PIC16F62X Silicon/Data Sheet Errata

The PIC16F62X (Rev. A) parts you have received conform functionally to the Device Data Sheet (DS40300B), except for the anomalies described below.

Clarifications/Corrections to the Data Sheet:

PIC16F62X

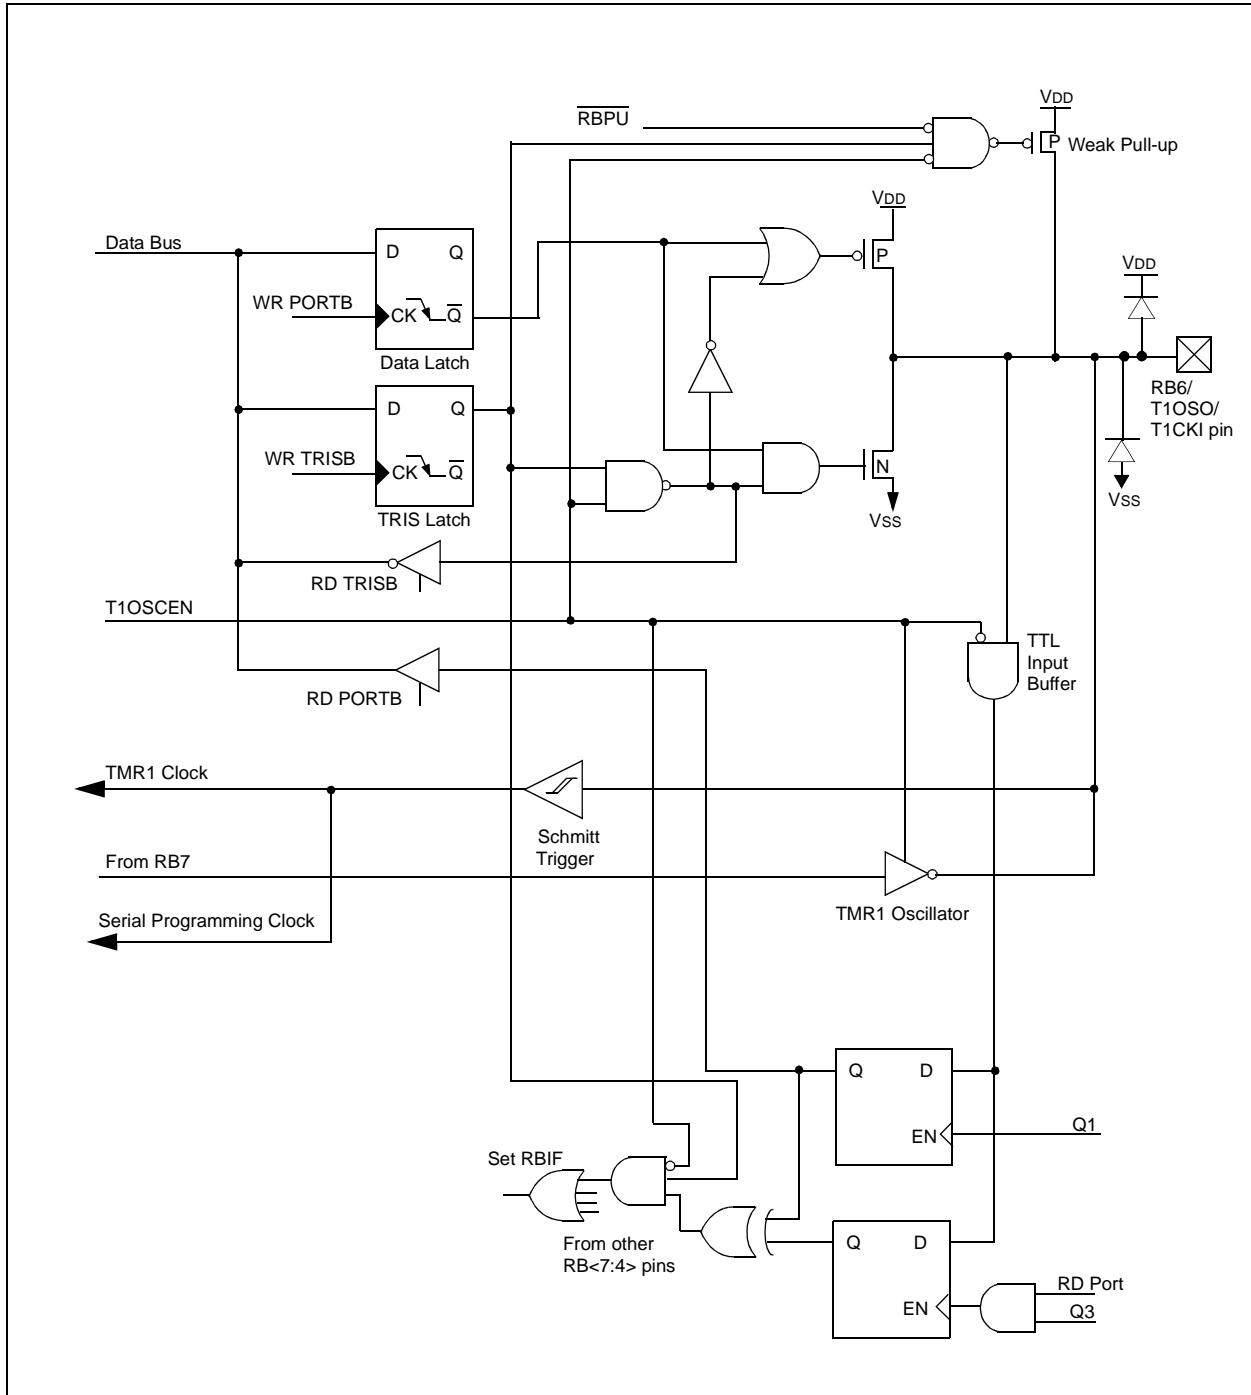
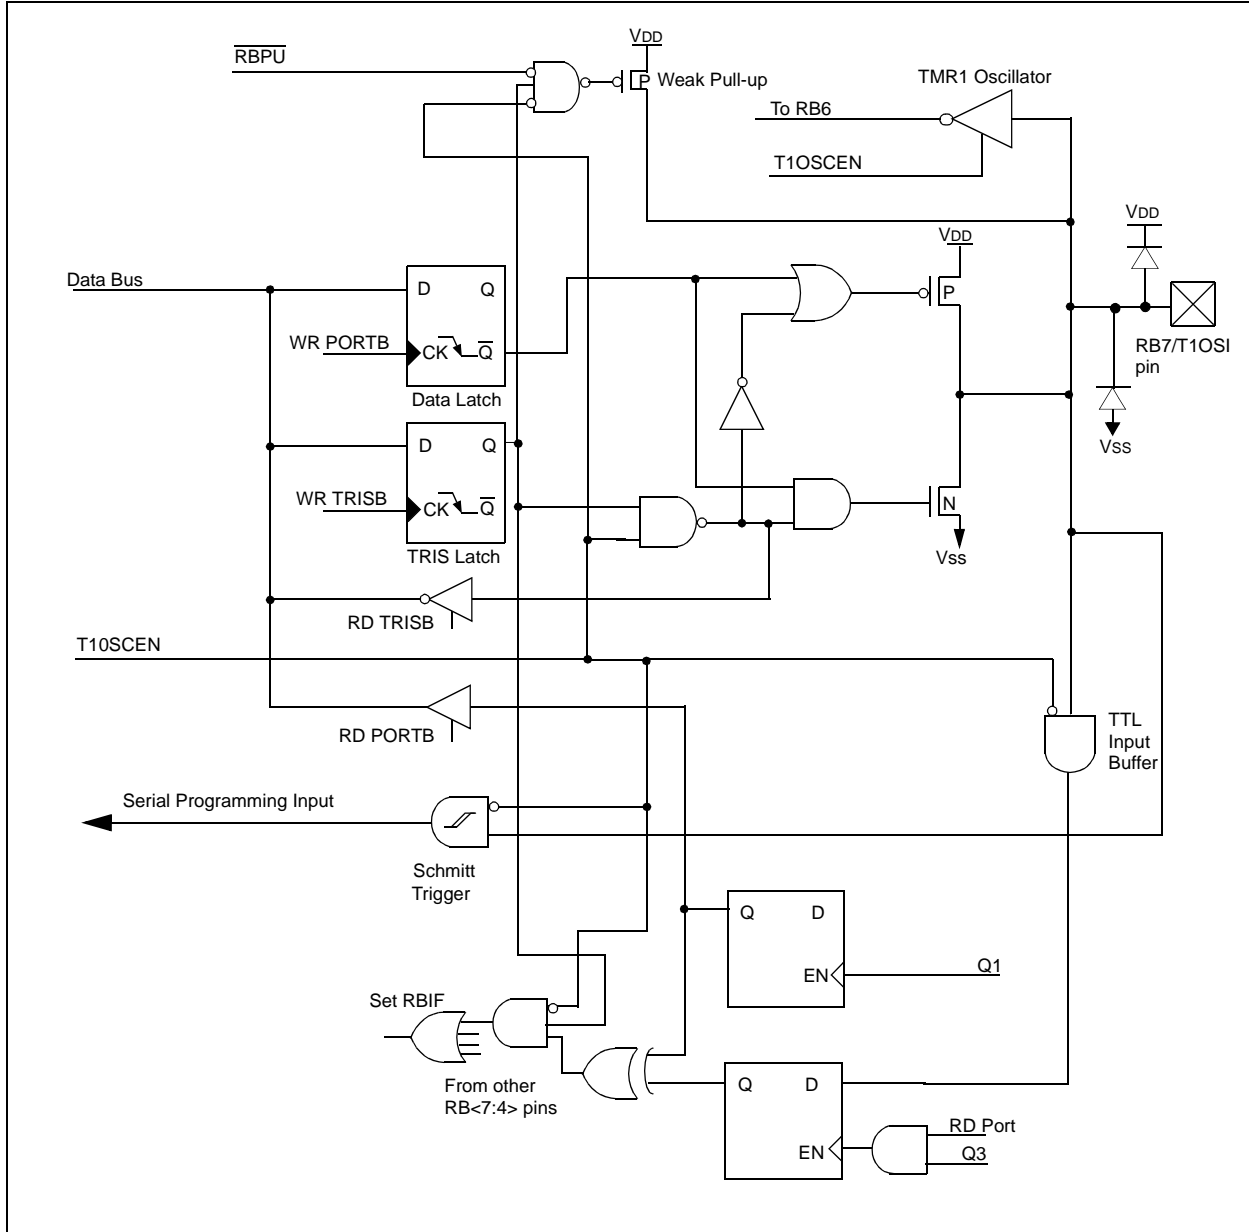
1. Module: I/O Ports

A read of the PORTB Data Direction Register (TRISB) returns the Data Direction state on the port pins themselves and not the contents of the TRISB register latch.

FIGURE 5-5: BLOCK DIAGRAM OF THE RA5/MCLR/VPP PIN

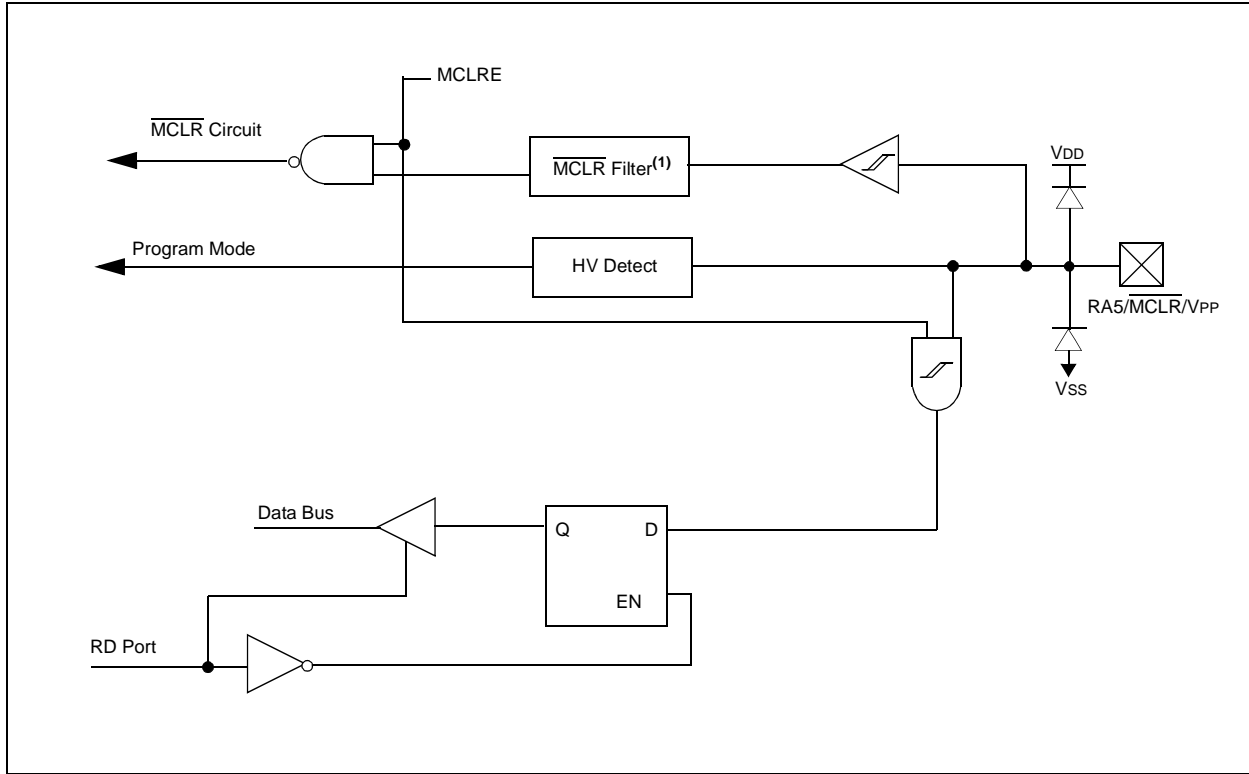
3. Module: I/O Ports (RA5/MCLR/VPP)

The following block diagram shown in Section 5, Figure 5-5 is incorrect. The following figure should be used instead.
